Urgent Field Safety Notice

**Microdot Droplet Pen Needle 4mm x 32G28G, type 810,
catalogue number 8065.**

FSCA – ZJ-S 379/2017

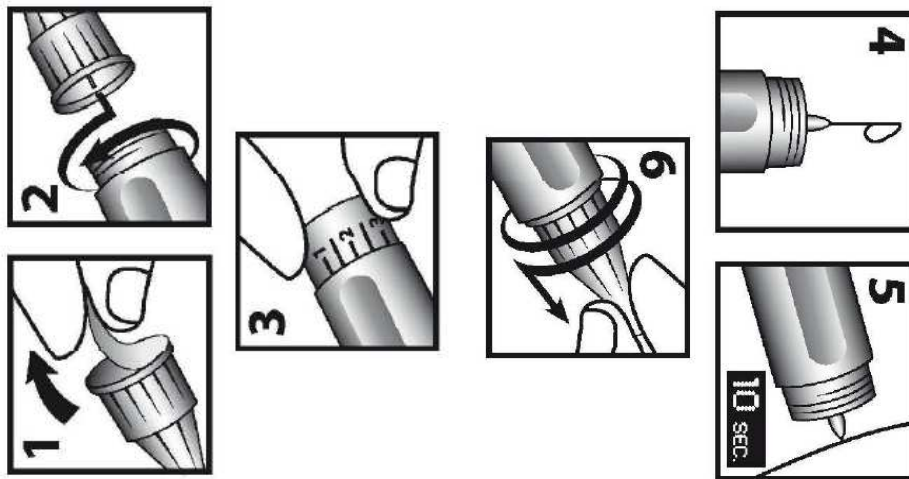
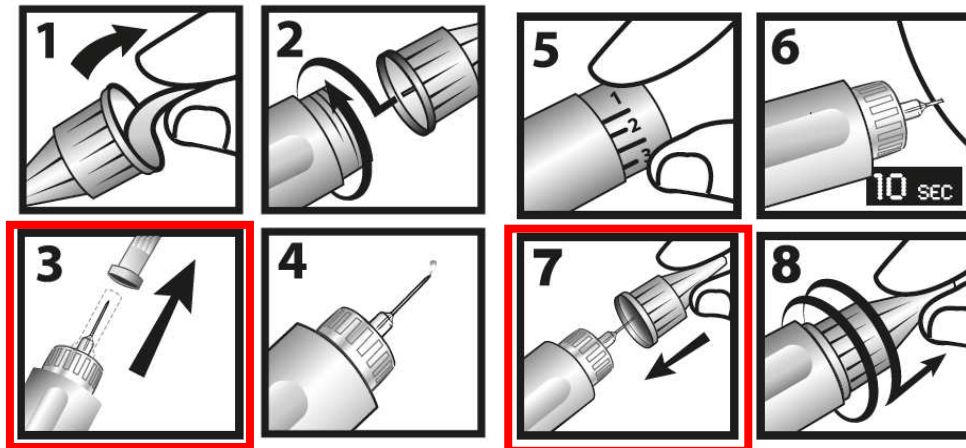
The current IFU shows 6 steps of use of the device. The step related to correct removal of the inner and outer cap is not included.

Within corrective actions there will be added two additional steps (step 3 and step 7) to IFU, explaining how to remove and put on the caps correctly:

Within immediate corrective actions there will be a leaflet included to next shipments, containing the IFU with new steps included.
